COUNTY OF EL PASO, STATE OF COLORADO
GRADING AND EROSION CONTROL PLANS
DECEMBER 2021

Reviewed by:
Glenn Reese, P.E.
Stormwater Engineer II
GlennReese@ElPasoCo.com
719-675-2654

STERLING RANCH ROAD & BRIARGATE PARKWAY GESC		H-SCALE 1"=60'		No.	REVISION	BY	DATE	 J-R ENGINEERING A Westland Company		PREPARED FOR SR LAND, LLC 20 BOULDER CRESCENT SUITE 201 COLORADO SPRINGS, CO 80903 JAMES F. MORLEY (719) 471-1742	UNTIL SUCH TIME AS THESE DRAWINGS ARE APPROVED BY THE APPROPRIATE REVIEWING AGENCIES, JR ENGINEERING WILL BE RESPONSIBLE ONLY FOR THE PURPOSES DESIGNATED BY WRITTEN AUTHORIZATION.
GRADING AND EROSION CONTROL PLANS		V-SCALE N/A									
		DATE 3/11/2022									
		DESIGNED BY RAB									
		DRAWN BY CGV									
		CHECKED BY									
SHEET 3 OF 9											
JOB NO. 25188.03

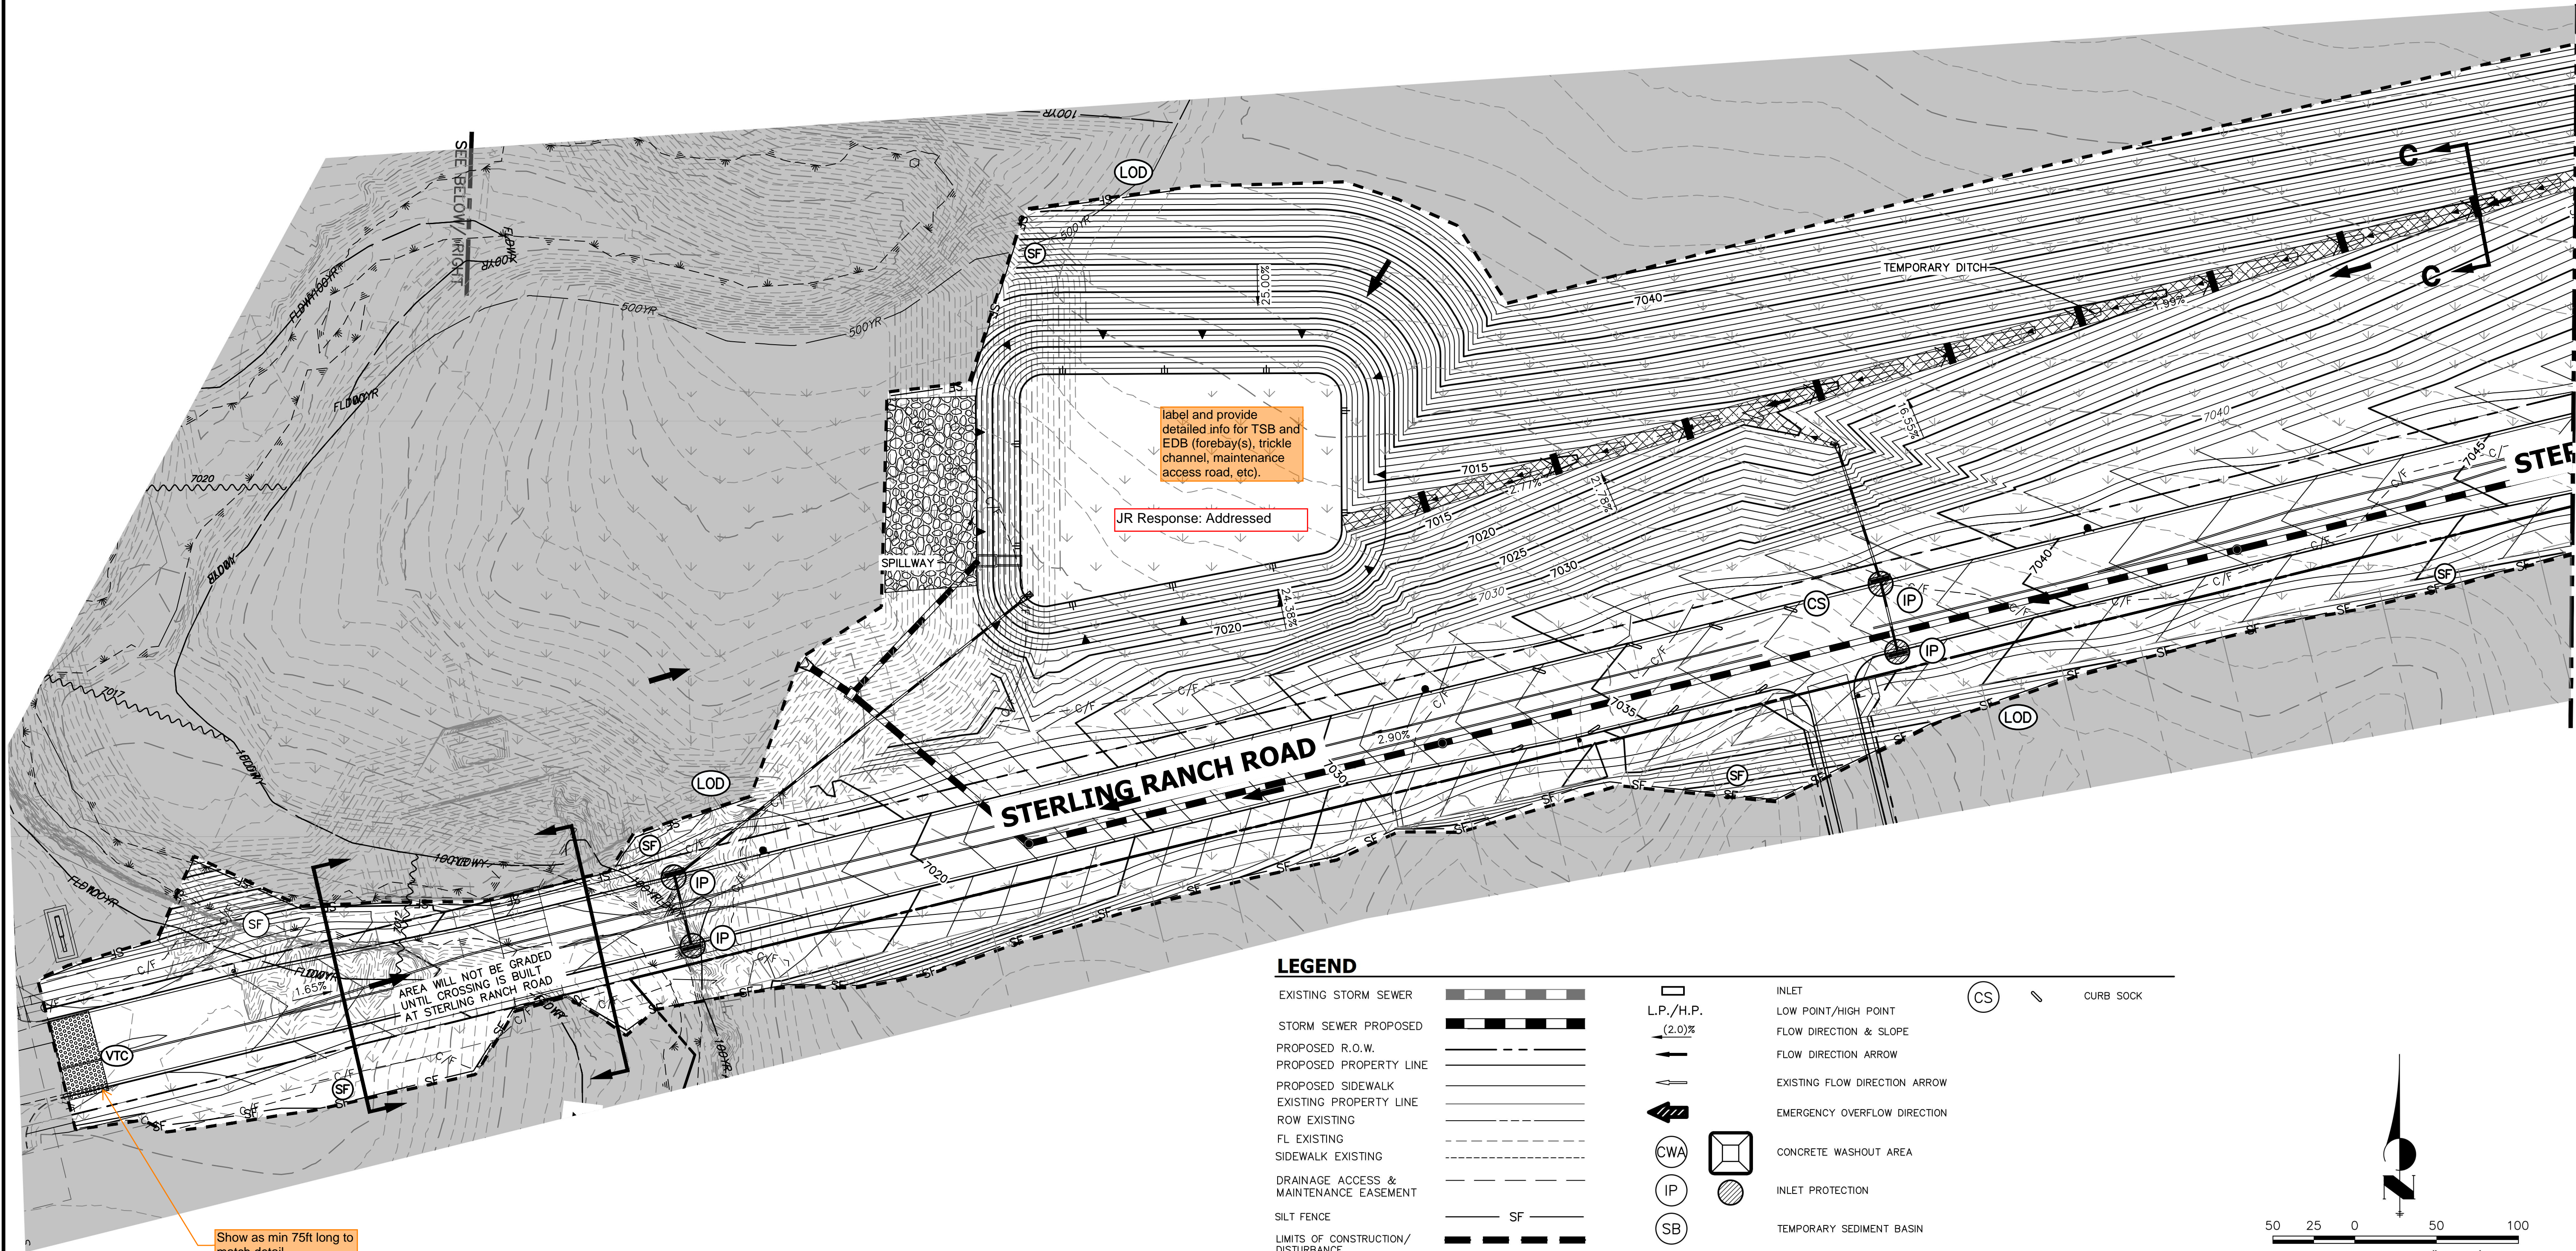
label and provide detailed info for TSB and EDB (forebay(s), trickle channel, maintenance access road, etc).

Show as min 75ft long to match detail.

Label as Section C-C?

Channel section does not match design
section in Dr letter. Please update
Label and show section locations to
match those on drainage plan.
